ENVIRONMENTAL COMMISSION MOTION 20221102-002

Subject: Brodie Oaks Redevelopment PUD, C814-2021-0099

NAME & NUMBER OF PROJECT: Brodie Oaks Redevelopment PUD C814-2021-0099

Brodie Oaks Redevelopment PUD

Exhibit G: Grading Plan

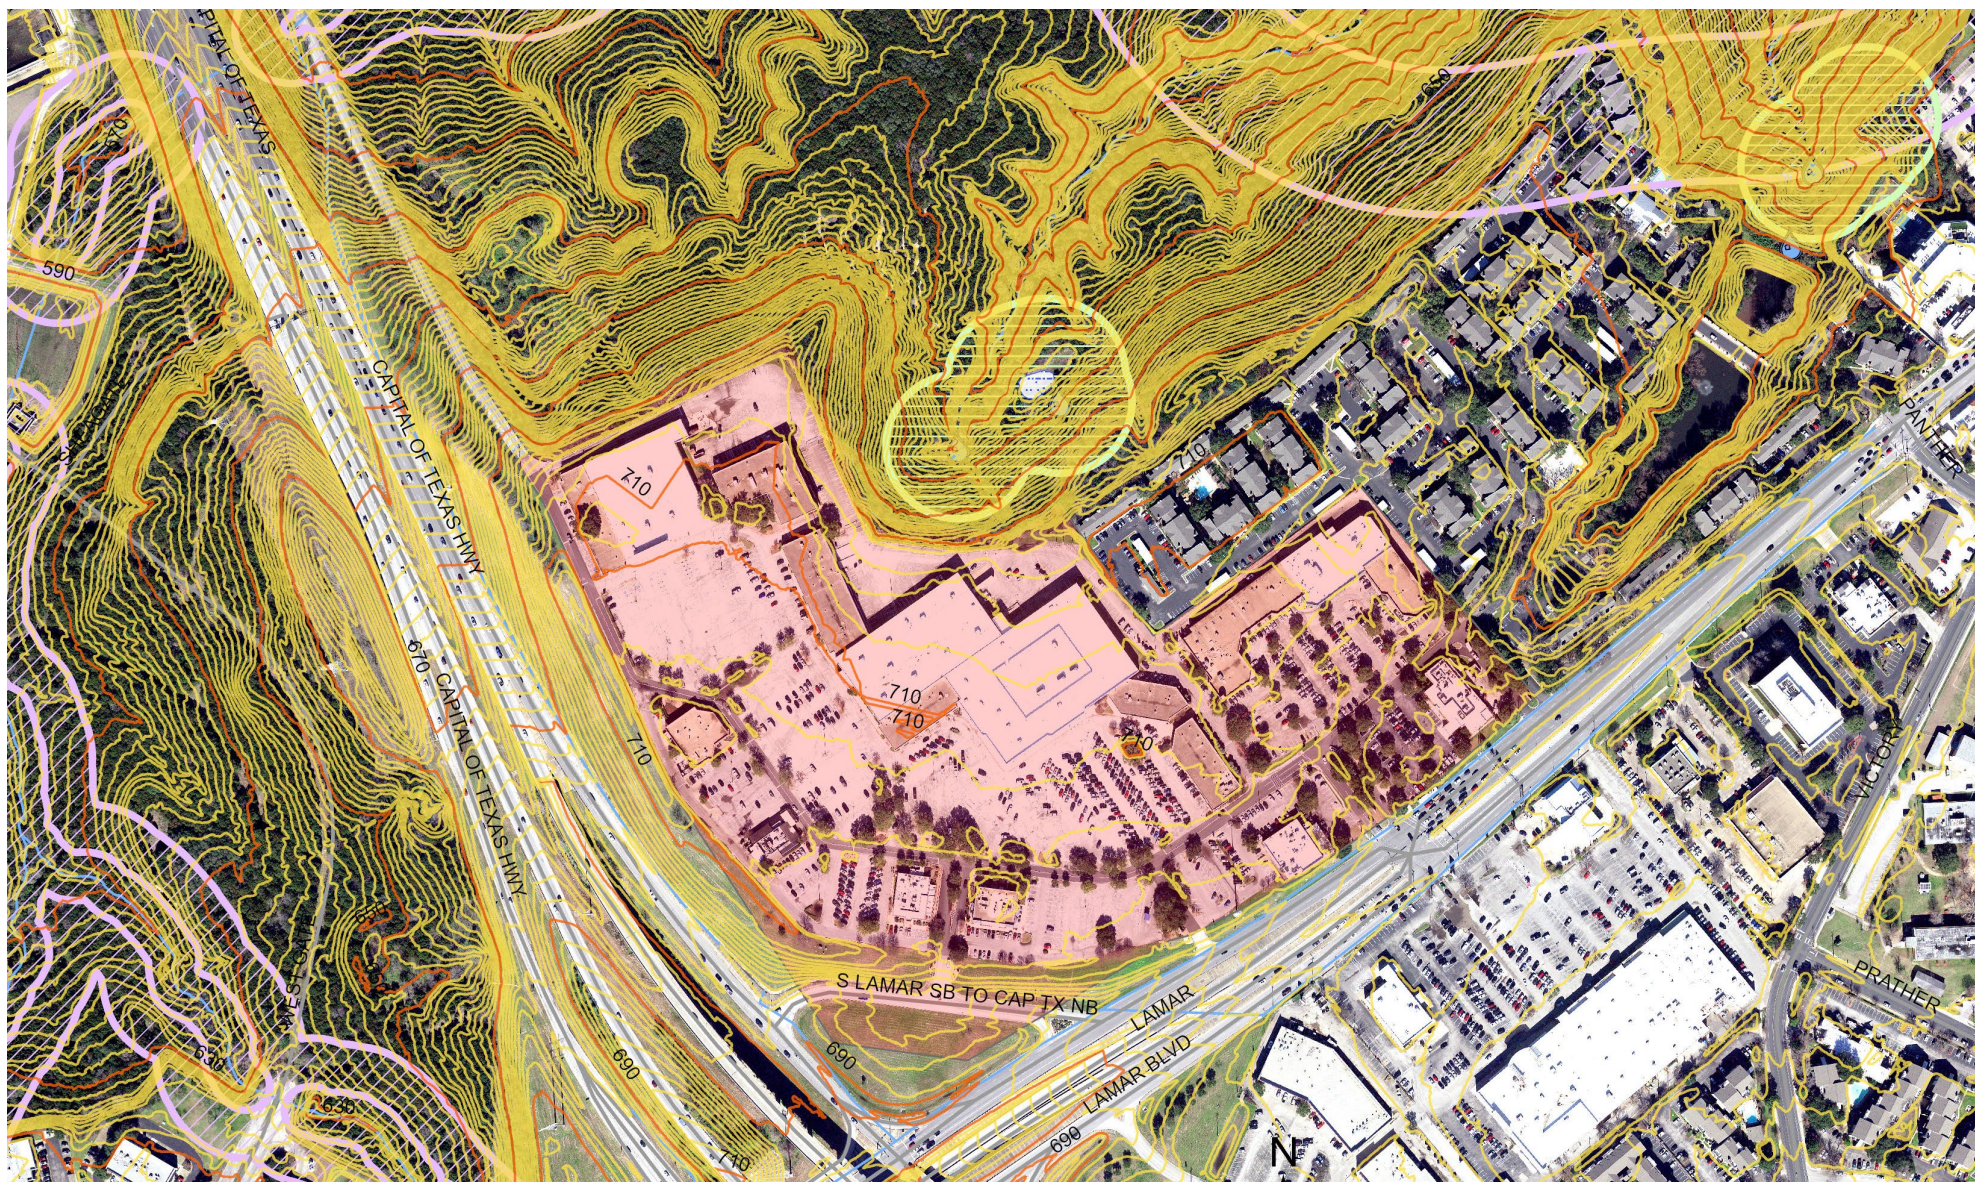
- **25-8-341 (Cut Requirements)** shall be modified to allow cut not to exceed a maximum of fourteen (14) feet as indicated on Exhibit G.
- **25-8-342 (Fill Requirements)** shall be modified to allow fill not to exceed a maximum of fourteen (14) feet as indicated on Exhibit G.
- **25-8-281 (Critical Environmental Features)** shall be modified to allow encroachment into CEFs as indicated on Exhibit F.
- **SOS Ordinance Section A of 25-8-514 (Pollution Prevention Required)** shall be modified to allow a maximum impervious cover for the site of 56% net site area.

Exhibit F: Environment

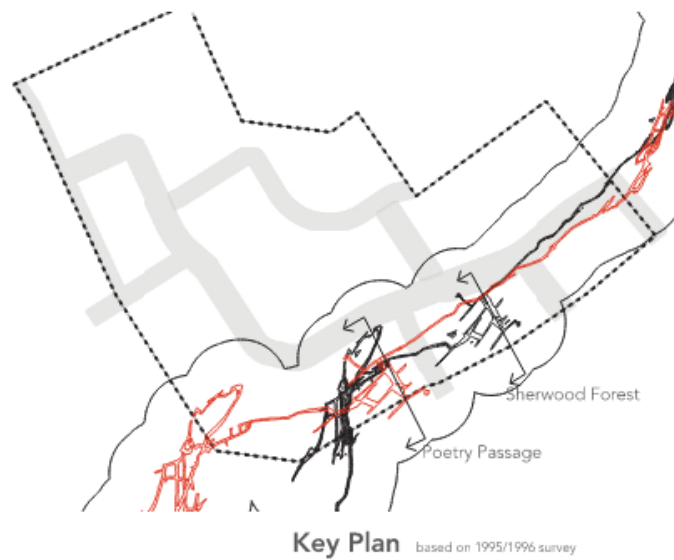
1. Modify CEF setback for S-1/S-2
2. Impact to Airman's Cave CEF setback is limited of up to 80' with conditions
3. Protective fencing for CEFs

Exhibit F: Water Quality

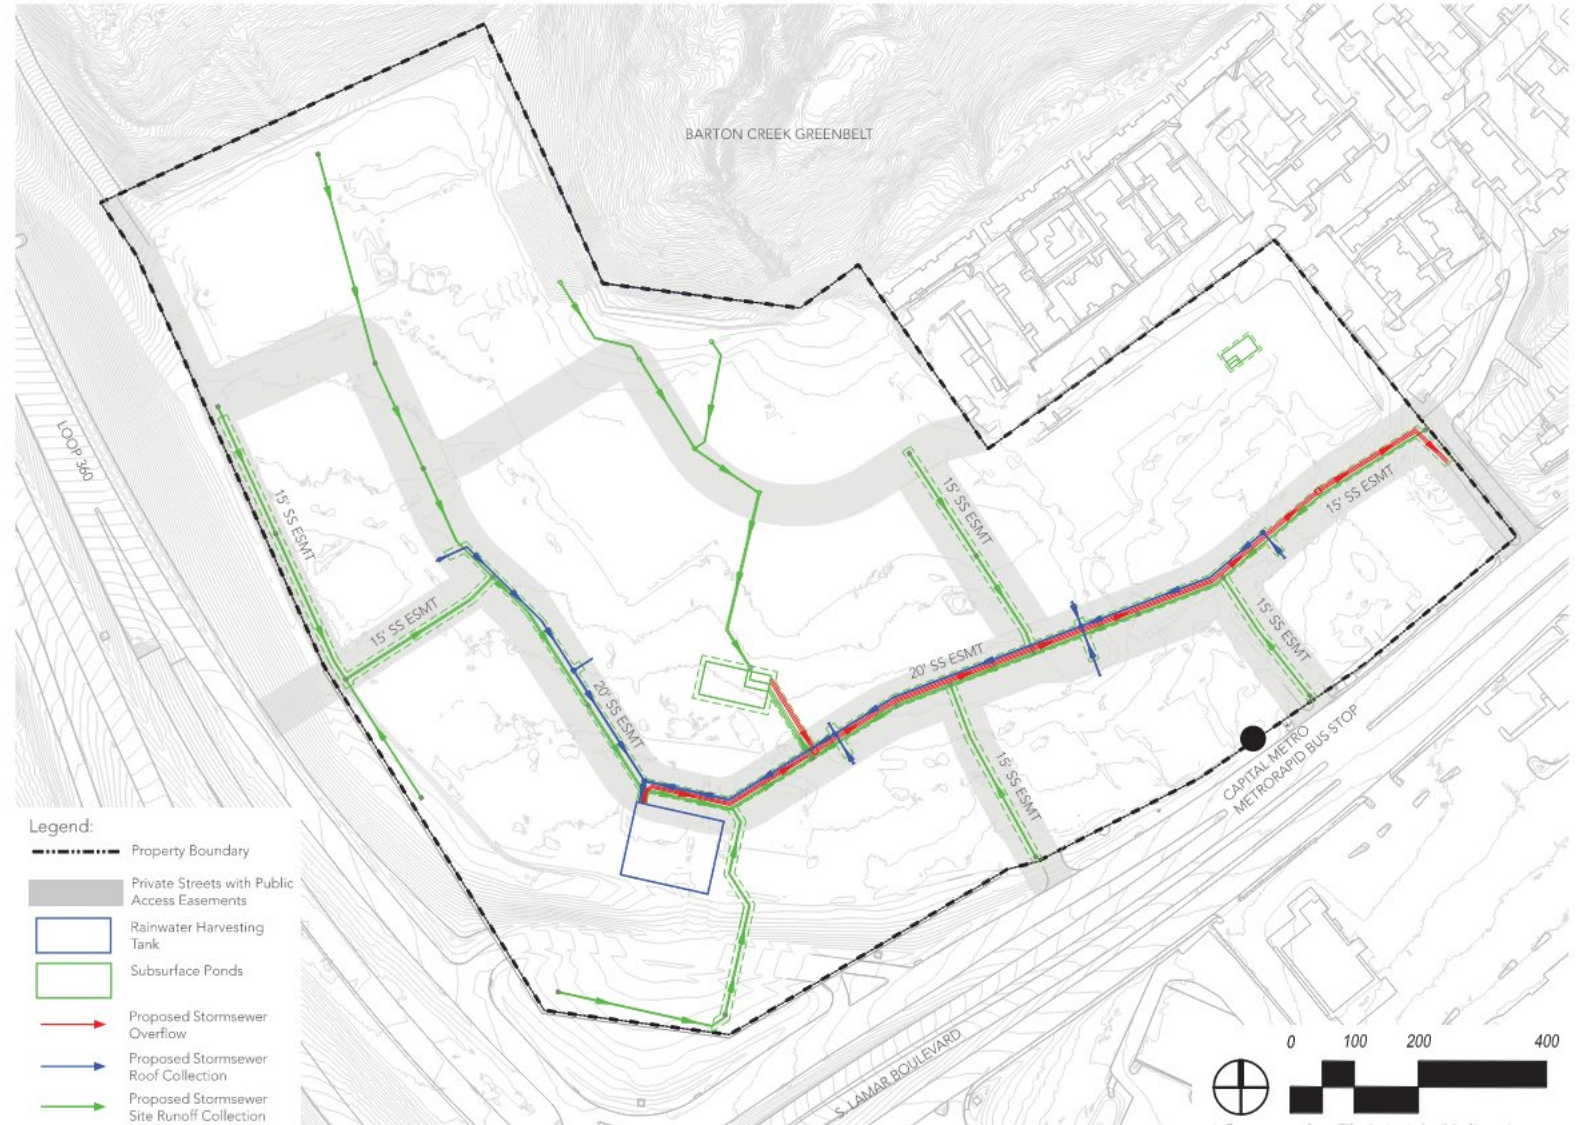
1. Brodie PUD will comply with SOS with subgrade ponds for retention/reirrigation system and rainwater harvesting with beneficial reuse
2. Infiltration testing
3. Trenching > 5' will be inspected by geologist
